**TO:** All Potential Respondents  
RFB 2013 Palm River Restoration Phase II East McKay Bay

**SUBJECT:** Response to Questions

**PALM RIVER RESTORATION (W367)**  
**EAST Mc KAY BAY STORMWATER AND HABITAT**  
**RESTORATION SITES**  
 FOR  
**SOUTHWEST FLORIDA WATER MANAGEMENT DISTRICT**

**DRAINAGE STRUCTURE S200 STRUCTURAL DETAILS**

**4 SECTION C-C**  
 34.1 N.T.S.

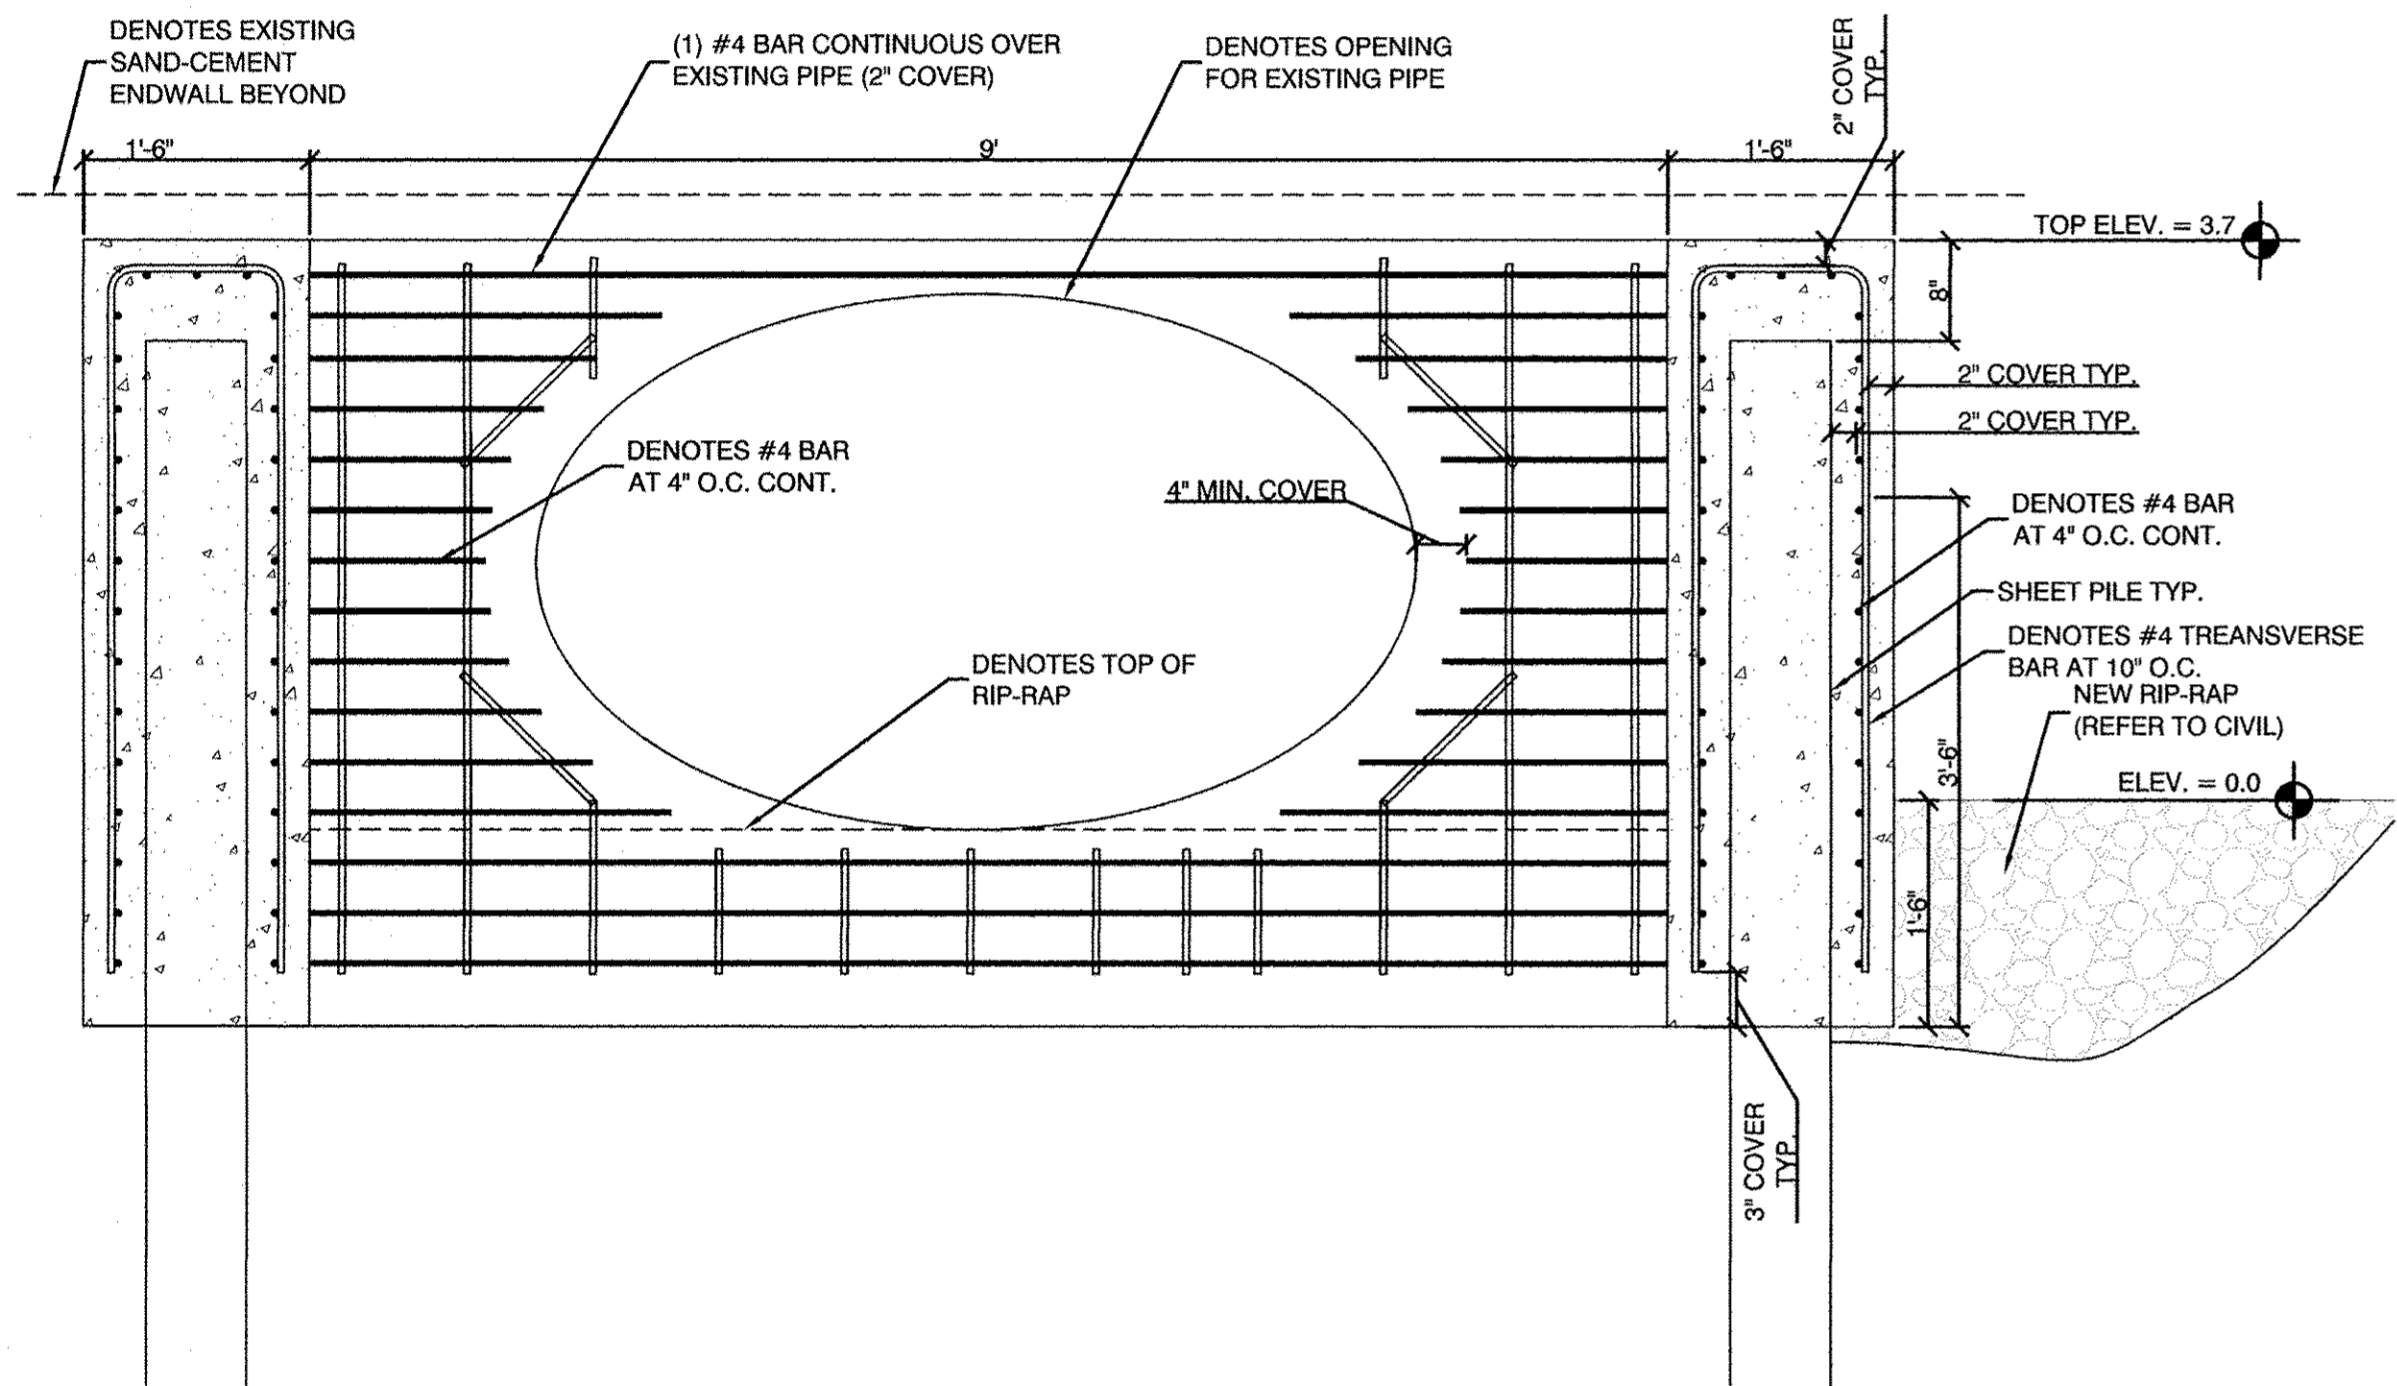
**QUESTION:** Please provide the Structural Plans for Weir Structure S200 as referenced on plan sheet 33.

**ANSWER:** Please see the attached Structural Plans (2 pages).
